Product Change Notification / SYST-23CMIU808

ERRATA - dsPIC33CK256MP508 Family Silicon Errata and Data Sheet Clarification

Description of Change: Added data sheet clarification 3 (Electrical Characteristics).

dsPIC33CK256MP508 Family Silicon Errata and Data Sheet Clarification

FIGURE 1-1: I/O RAMP

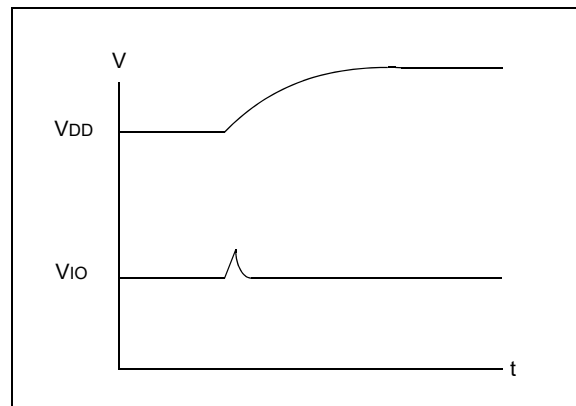
During a fast device power-up when the V_{DD} ramp is less than 4 mS, the I/O pins may drive up to 100 μ A current for a duration of up to 10 μ S (Figure 1-1).

1. Slow down the V_{DD} ramp time (greater than 4 mS for V_{DD} to ramp 0V to 3.3V).
2. Ensure the circuitry that is connected to the pins can endure this pulse.

Example applications affected may include complementary power switches, where a transient current shoot-through might occur. High-voltage applications with complementary switches should power the high-voltage 200 μ Sec later than powering the dsPIC[®] device to avoid the current shoot-through. This behavior is specific to each device and not affected by aging.
